UNITED STATES PATENT AND TRADEMARK OFFICE

APPLICATION NO.	FILING DATE	FIRST NAMED INVENTOR	ATTORNEY DOCKET NO.	CONFIRMATION NO.
09/927,547	08/13/2001	Masumi Kubo	829-583	7121

# Office Action Summary

**FIG.11**

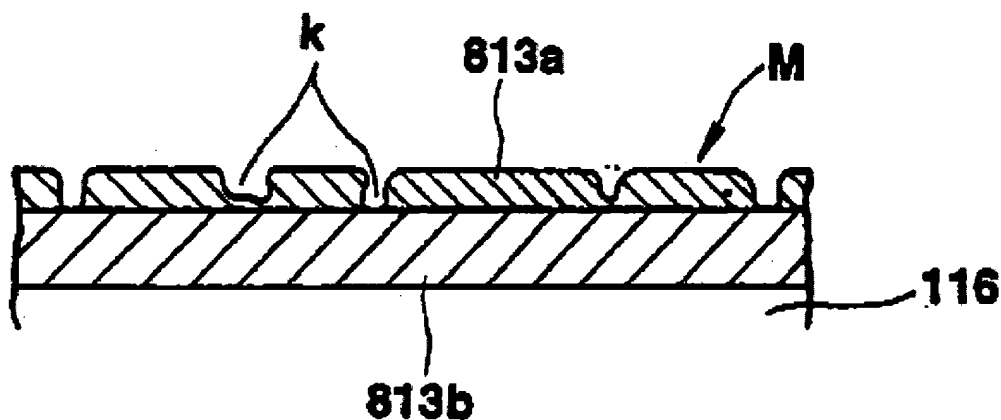
Yoshida discloses and shows in Figure 11 (reproduced below), a liquid crystal display device comprising:

- a first substrate (112) and a second substrate (111);
- a semitransparent reflection film (M) provided on the second substrate (111);
- a liquid crystal layer (125) interposed between the first and the second substrate; and

- a plurality of pixel areas provided for display, each of the plurality of pixel areas including a reflection area for performing display using reflective light and a transmission area for performing display using transmitted light;

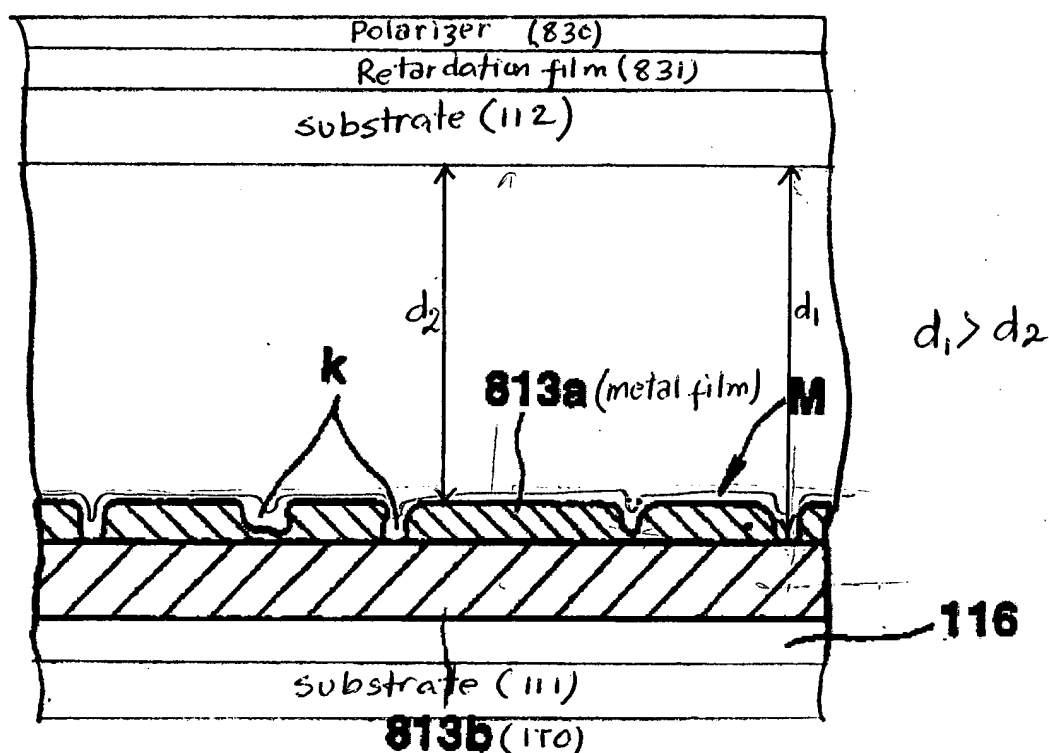
Yoshida also shows in Figure 11, a liquid crystal display device comprising:

- a first substrate (112) and a second substrate (111);
- a liquid crystal layer (125) interposed between the first substrate and the second substrate;
- a first polarizer (830) provided on a surface of the first substrate (112) which is on the opposite side of the liquid crystal layer (125);
- a second polarizer (832) provided on a surface of the second substrate (112) which is on the opposite side of the liquid crystal layer (125);
- a retardation plate (831) (applicant's first phase compensation element) provided between the first polarizer (830) and the liquid crystal layer (125);

Wherein the semitransparent reflection film M is formed of an ITO layer (813b) (applicant's transmissive electrode region defining the transmission area) and a metal layer (813a) (applicant's reflective electrode region defining the reflection area), which are in correspondence with each pixel area on the second substrate (111) (Fig. 14).

Further, it is clear from Figures 11 and 14, that the transmissive electrode region is formed closer to the second substrate than the reflective electrode region. Thus, a thickness (d1) of the liquid crystal layer in the transmissive electrode region and a

thickness ( $d_2$ ) of the liquid crystal layer in the reflective electrode region are defined by a relationship  $d_1 > d_2$ . (Please see the following Figure, reproduced by the examiner omitting the details and considering the semitransparent transparent film (M) including an ITO layer and a metal layer, as suggested by Yoshida in Fig. 14)
